To: Kristopher Byrd, Well Construction and Compliance Section Manager
From: Travis Kelly, Well Construction Program Coordinator
Subject: Review of Water Right Application G-19013
Date: September 23, 2020

Application # G- 19013

TO: Water Rights Section Date 9/17/2020
 FROM: Groundwater Section Jen Woody
 Reviewer's Name
 SUBJECT: Application G- 19013 Supersedes review of n/a
 Date of Review(s)

Figure 3. Water-Level Measurements in Nearby Wells

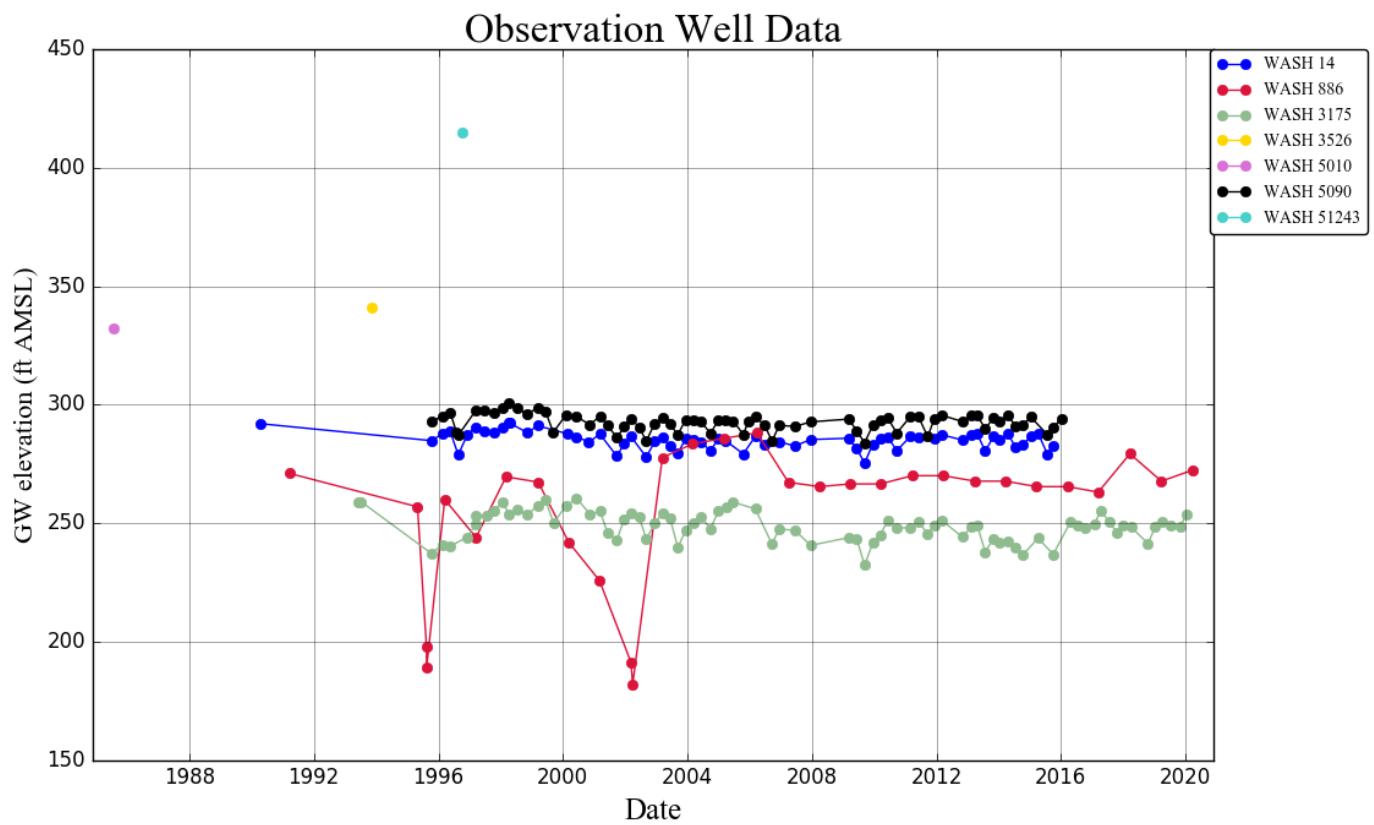
The proposed pumping rate of 9 gallons per minute (gpm) is unlikely to create drawdown interference with nearby wells that prevents access to water. Most neighboring tax lots are larger than 20 acres, indicating development by exempt wells is sparse. Nearby wells access a variety of water bearing zones within the CRBG aquifer system and show reasonably stable trends (see Figure 3). Water use and water level monitoring conditions are recommended to protect existing users. _____
